**Appendix 1**  
Communication and Correspondence

**RE: TOWN OF COLLINGWOOD EXISTING CONDITIONS MODELLING  
PROJECT INITIATION MEETING**

## DRAFT REPORT

**Figure 3-3 Study Watersheds**

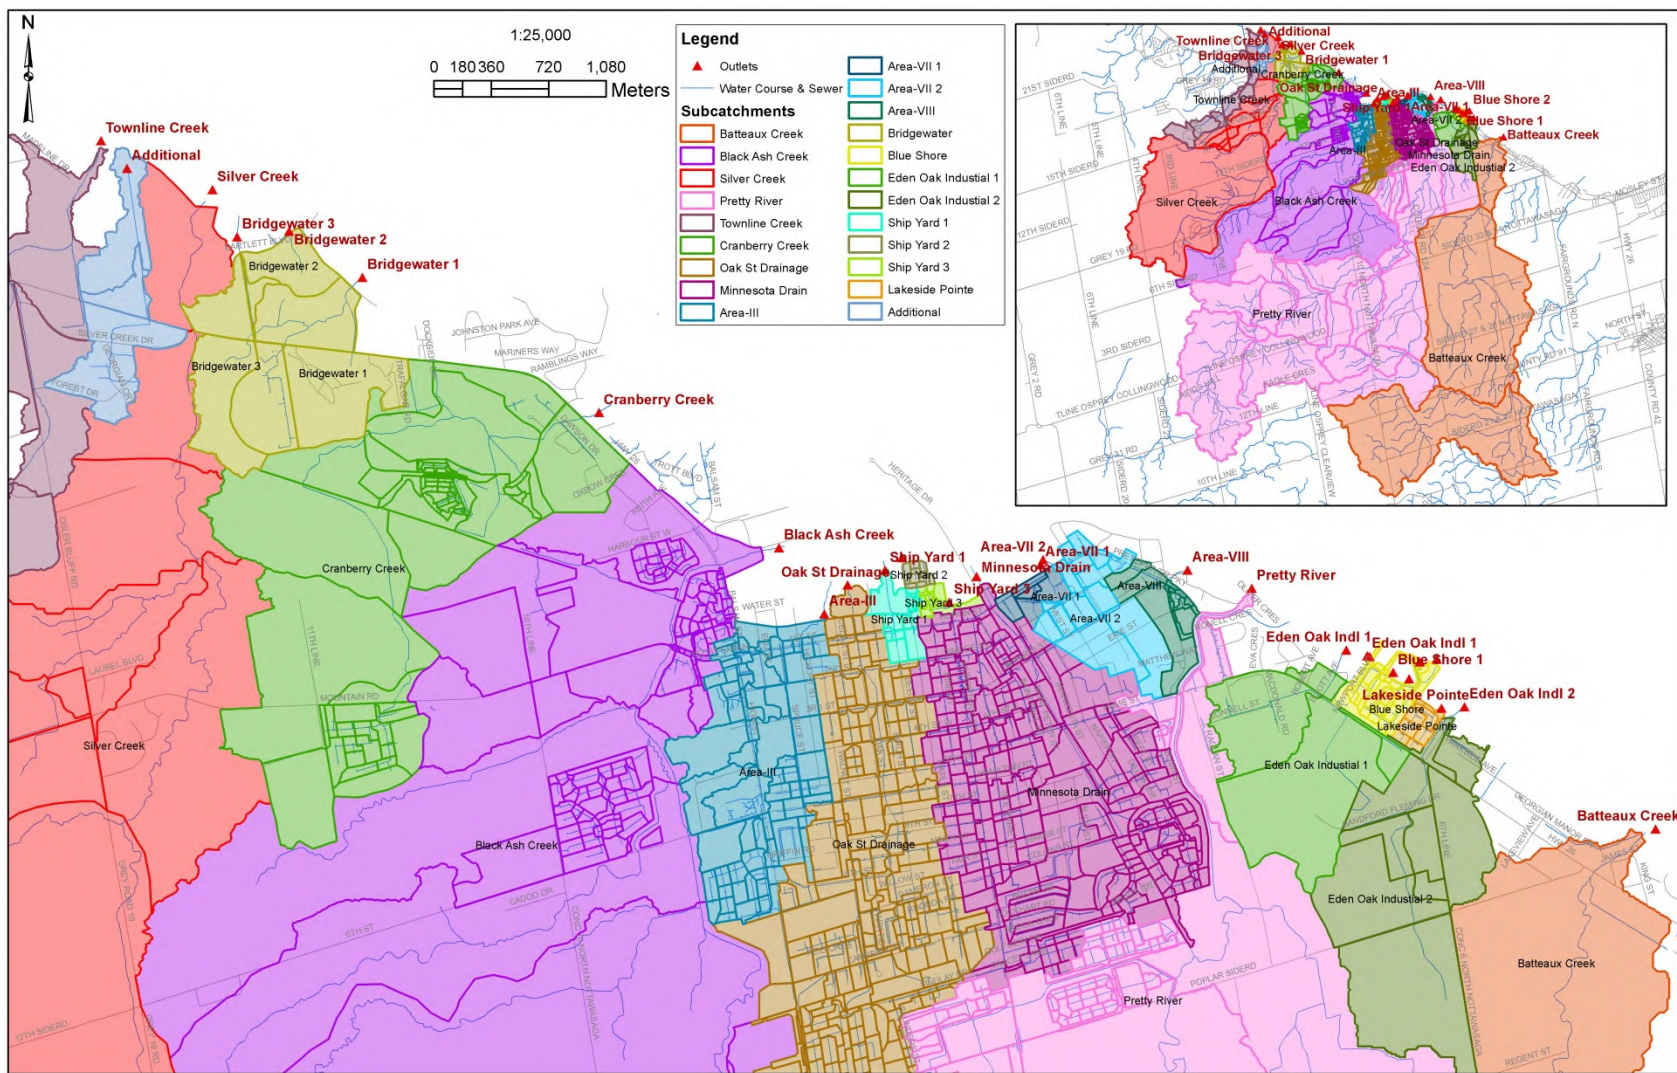
Comment 8: updated figure

Figure 4-3 Pretty River Watershed in PCSWMM

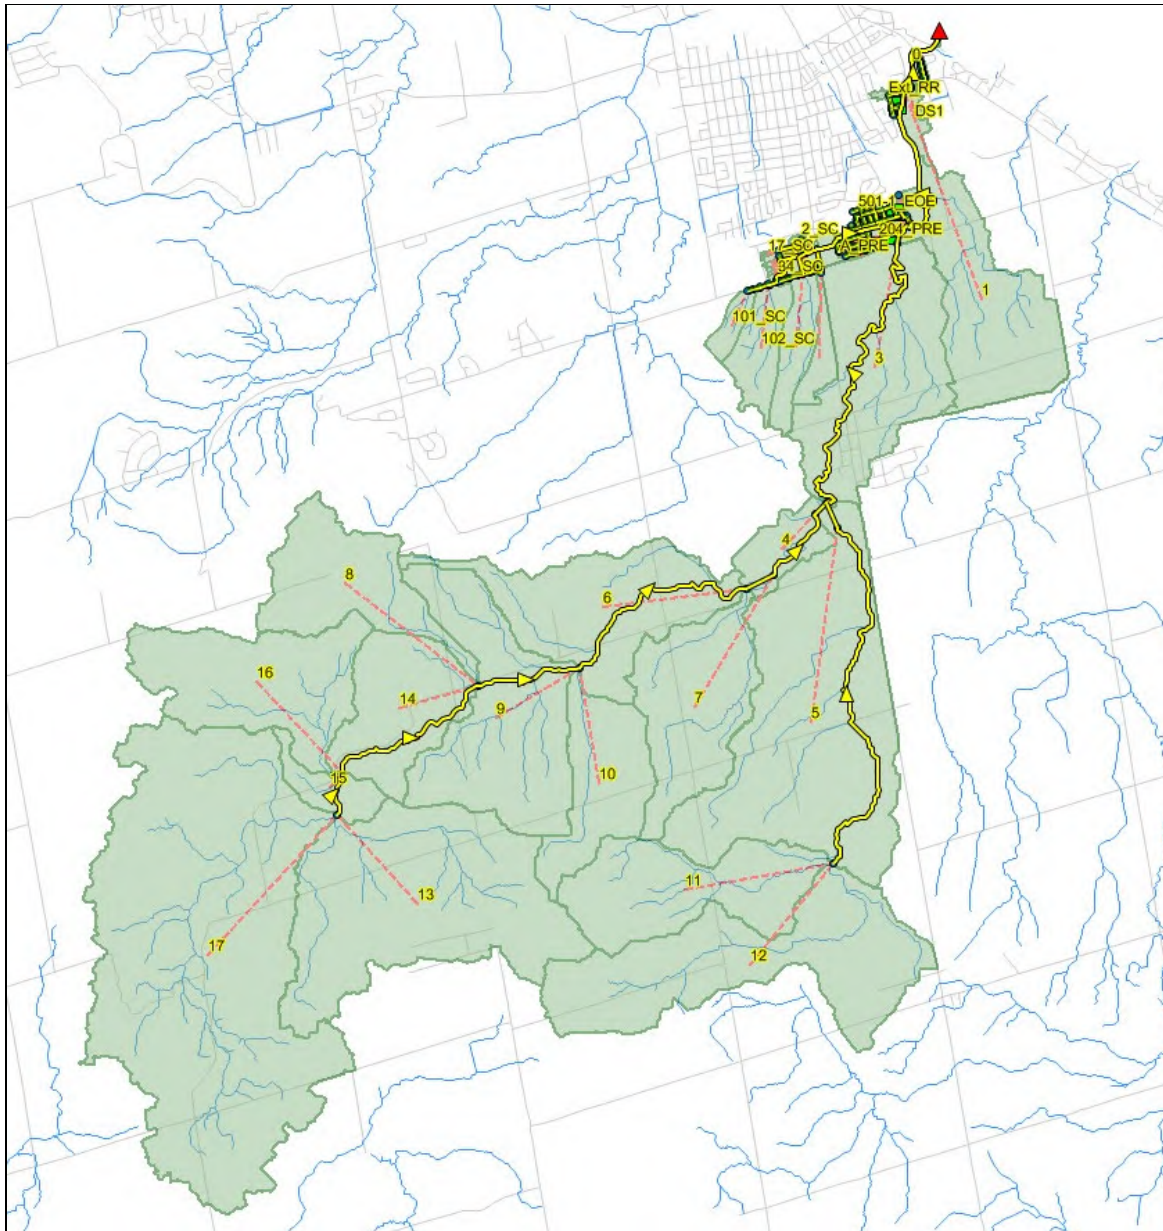
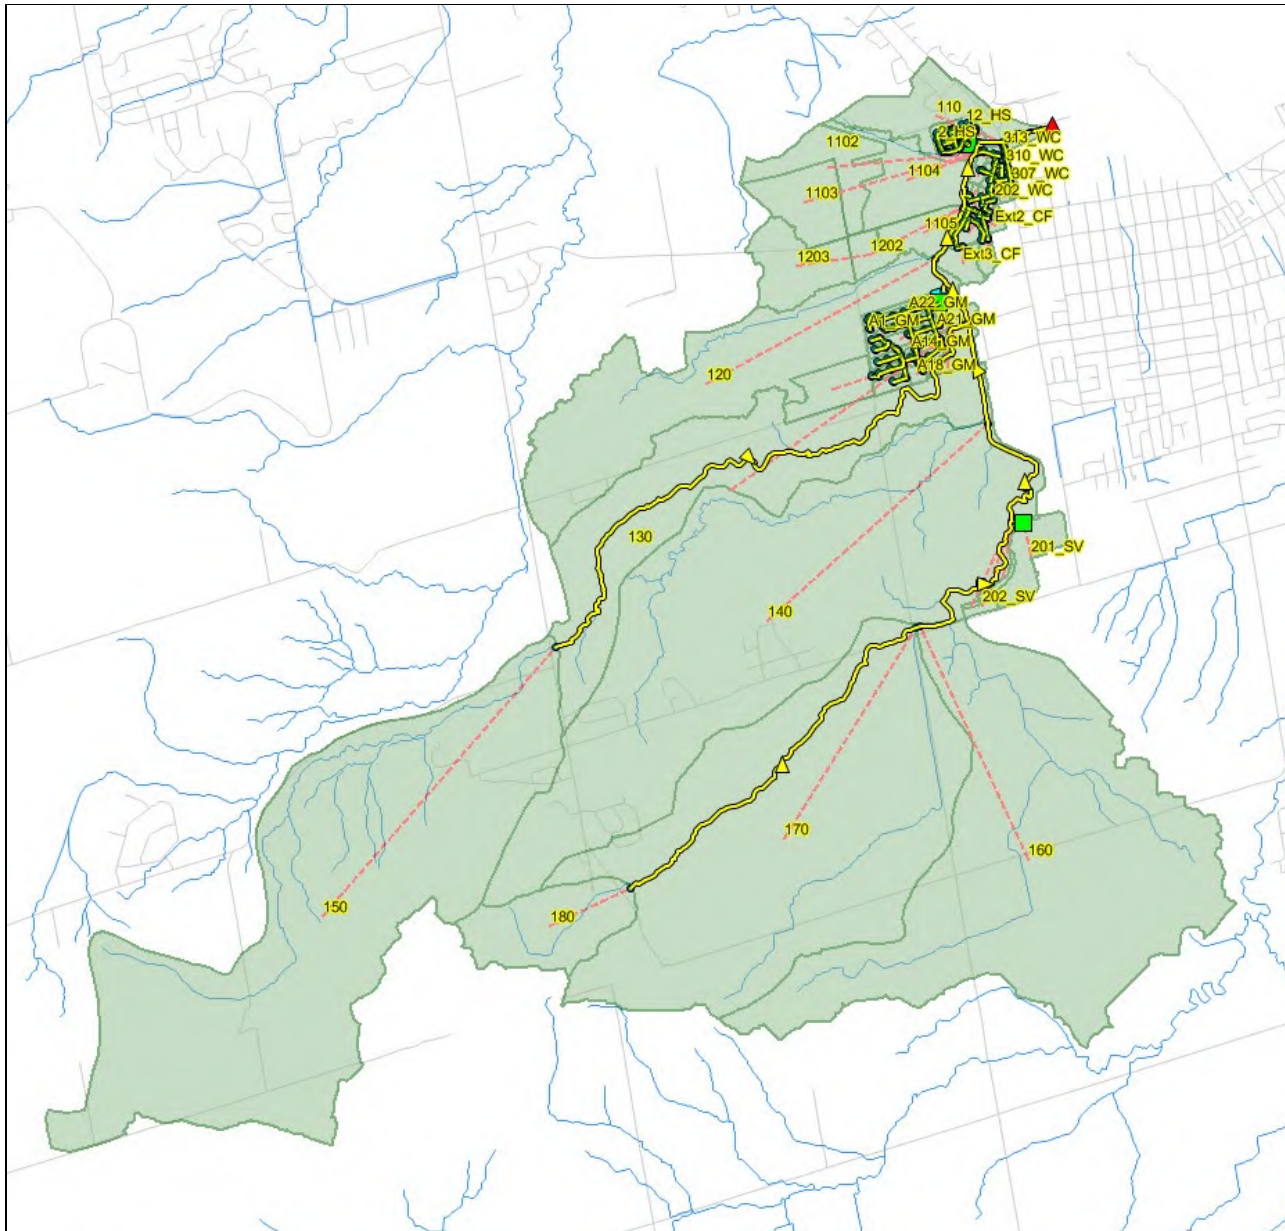
Comment 13: updated figures for BAC and Pretty River

Figure A2- 4 Installed Flow Monitor Locations

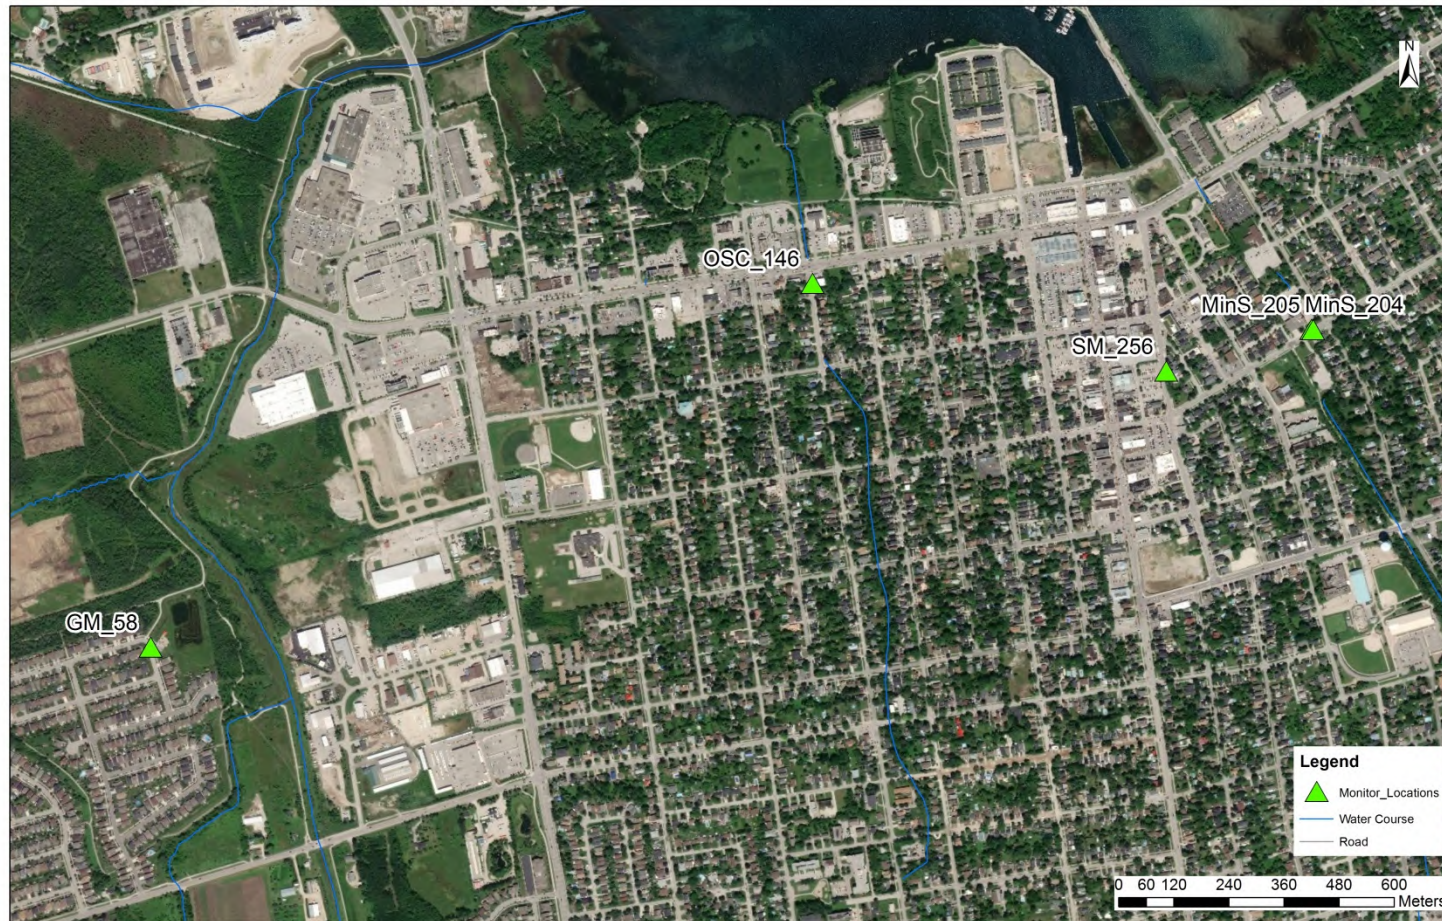
Comment Number	Page Number*	Comment	Greenland Response
4	12	Map should be updated	Map has been updated.
5	17	This is very concerning as summer events are very localized. Why wasn't a rain gauge installed? This is something Calder should have been able to do.	These were only small events. We have subsequently adjusted our calibration with several storm events in 2020.
6	35	Provide QA/QC report. LIDAR provider included text files showing the deviation between LIDAR and known surveyed points. This should be included in the appendix to confirm accuracy. NVCA will want this.	The documentation has been provided in the Pretty River report in an appendix that has been included with the package to the NVCA.
7	49	The explanation of these two scenarios should be moved from Section 7, to somewhere before this section.	The section was moved to another location.
8	50	References are not correct. All should be checked.	These were adjusted as required.

Comment 4:
